Date: August 5, 2003

Per our conversation on July 18, please provide a quotation for modifying the Emission Designator on the FCC grant for the SYS400 Base Station (FCC ID: BYM400).

Figure 1 BASE 400 Modulated with 2500Hz + 16dB

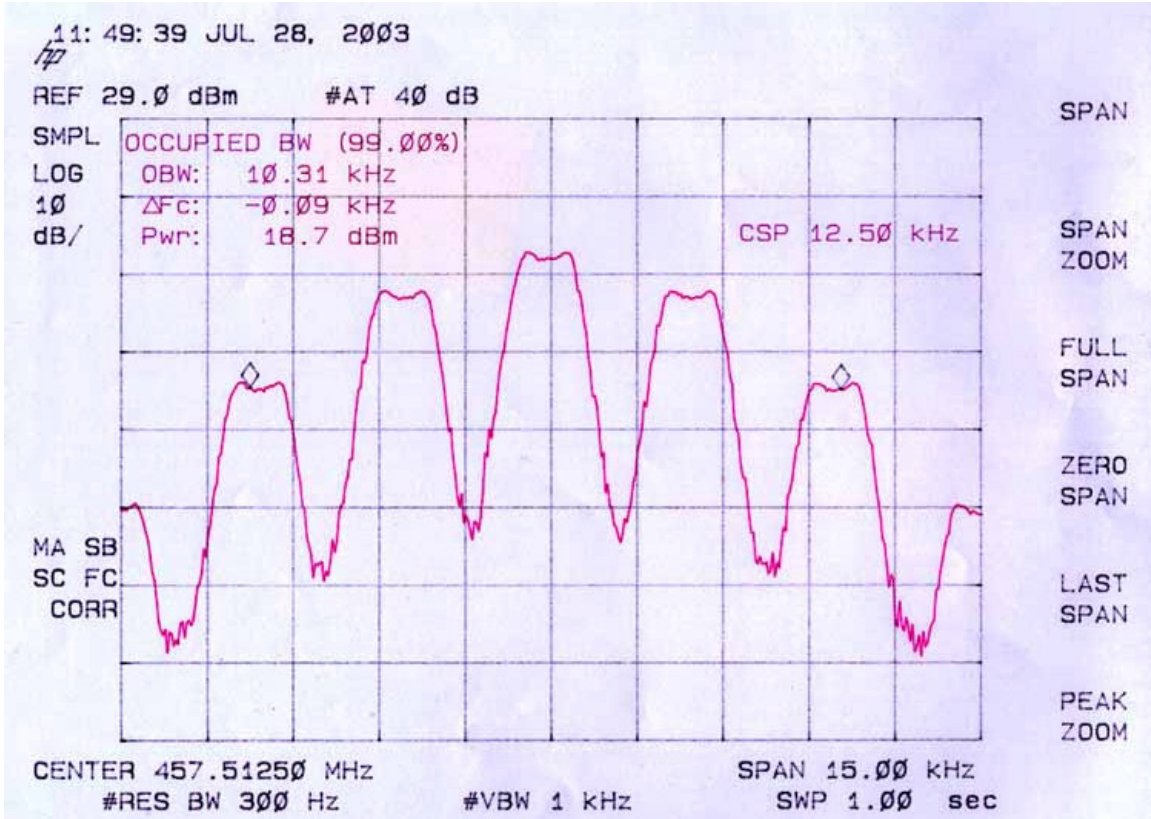
In addition, the occupied bandwidth measurement was in error for the Canadian submission. As can be seen on the attached graph, when using the spectrum analyzer's occupied bandwidth measurement function, the occupied bandwidth does not exceed 10.31 kHz. So, also please quote modifying the Canada certification (1860195460A) to reflect a bandwidth of 12.5 kHz.
